ADDENDUM NO. 1
TO INVITATION TO BID FOR THE
HALE CREEK ENHANCEMENT PILOT PROJECT
Project No. 26164001 Contract No. C0667
Invitation No. VW0077

ADDENDUM NO. 2
TO INVITATION TO BID FOR THE
HALE CREEK ENHANCEMENT PILOT PROJECT
Project No. 26164001 Contract No. C0667
Invitation No. VW0077

ADDENDUM NO. 3
TO INVITATION TO BID FOR THE
HALE CREEK ENHANCEMENT PILOT PROJECT
Project No. 26164001 Contract No. C0667
Invitation No. VW0077

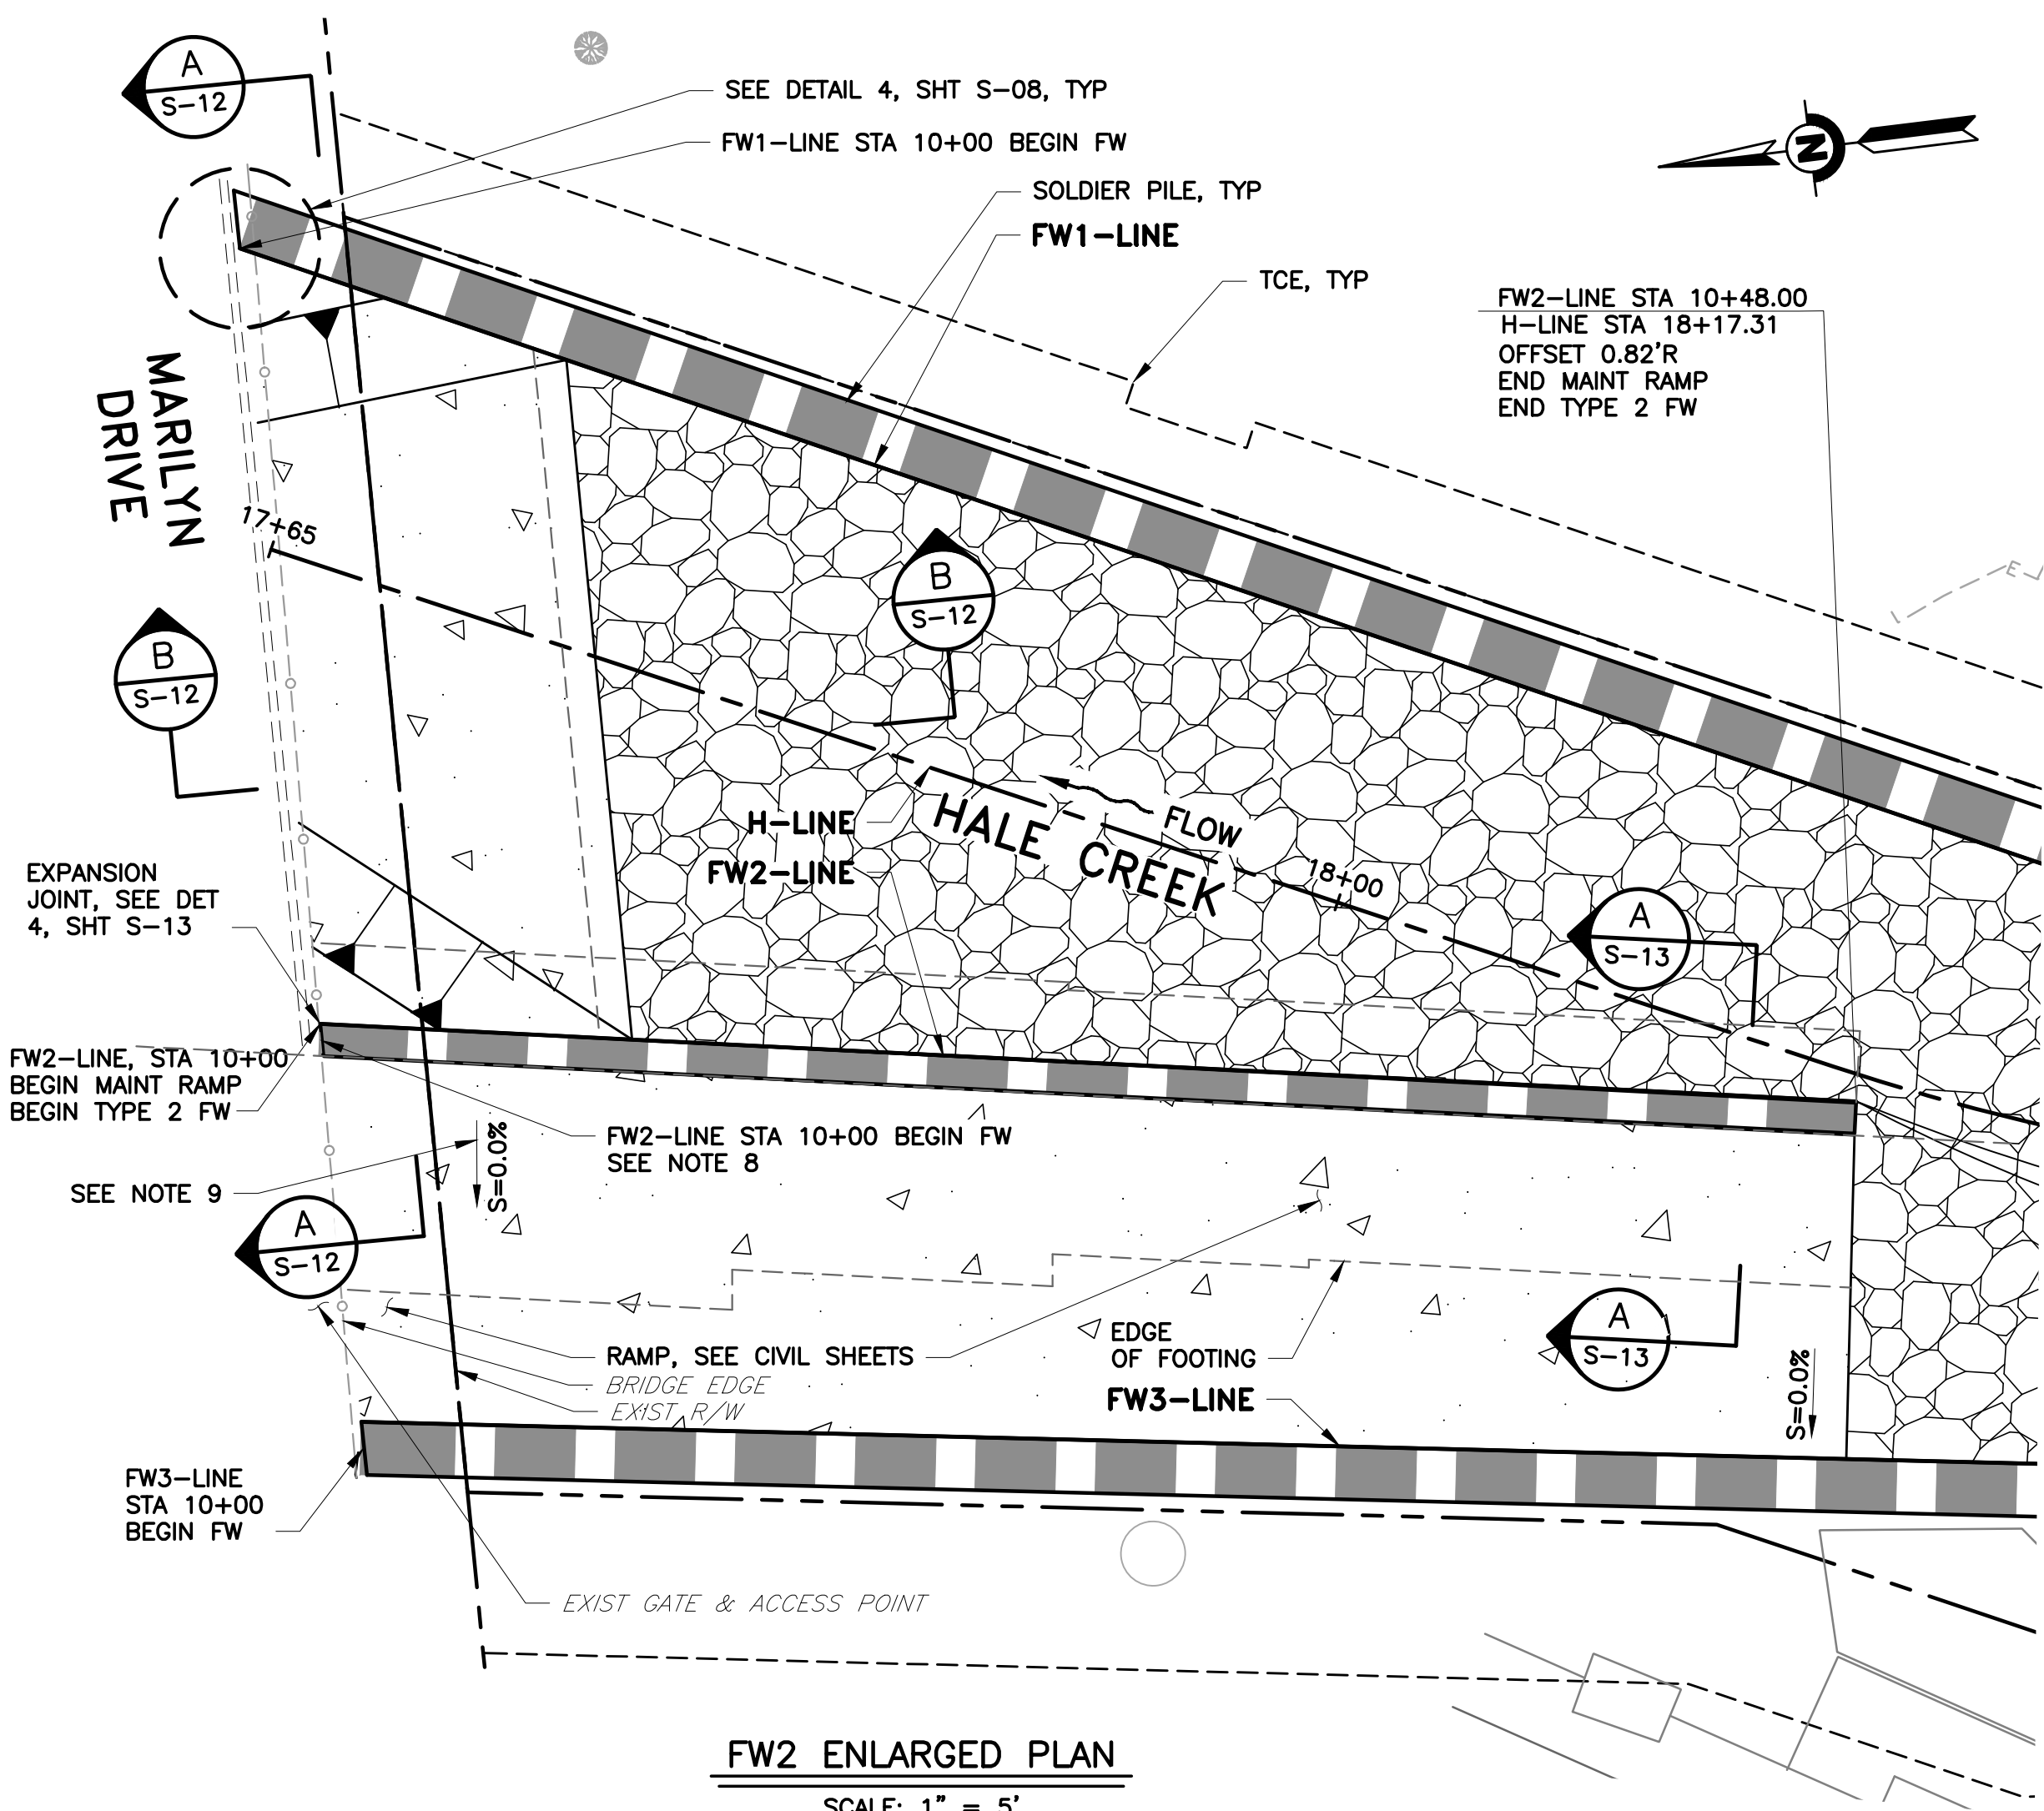
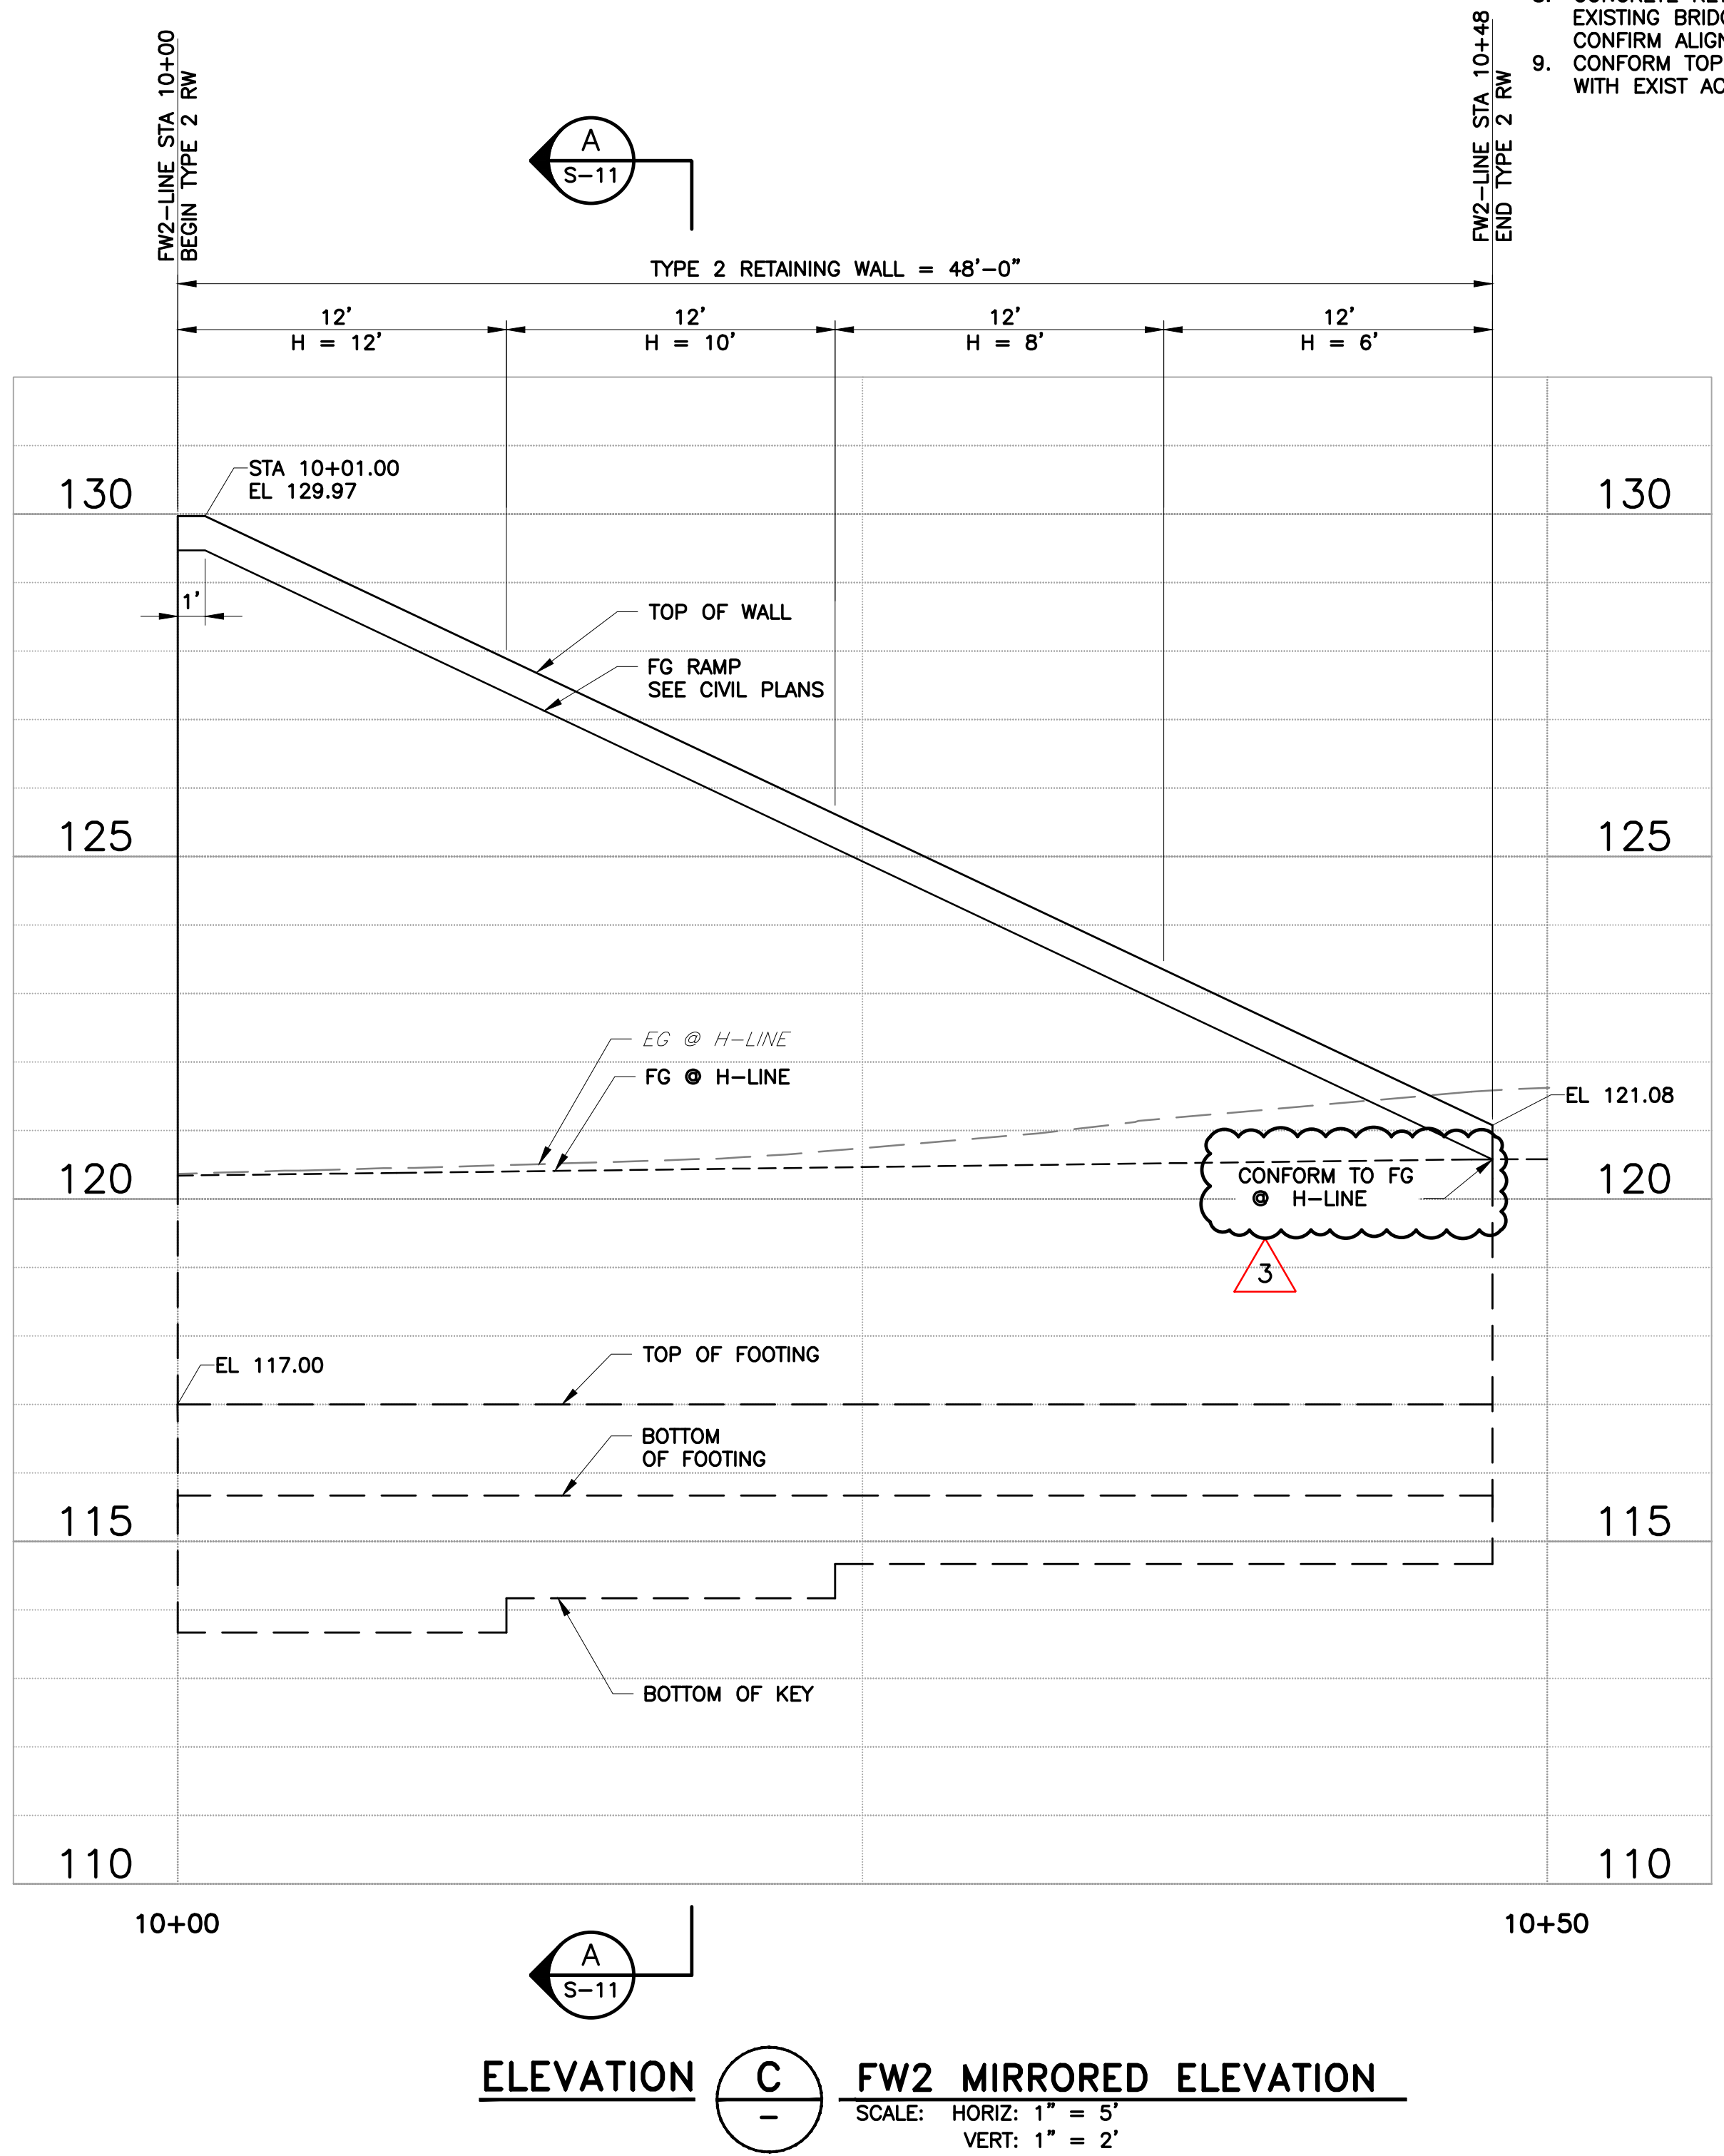
1. **REPLACE** Sheet Code G-02 (Sheet No. 2 of 58) with the attached new Sheet Code G-02.
2. **REPLACE** Sheet Code S-02 (Sheet No. 30 of 58) with the attached new Sheet Code S-02.
3. **REPLACE** Sheet Code S-03 (Sheet No. 31 of 58) with the attached new Sheet Code S-03.
4. **REPLACE** Sheet Code S-10 (Sheet No. 38 of 58) with the attached new Sheet Code S-10.
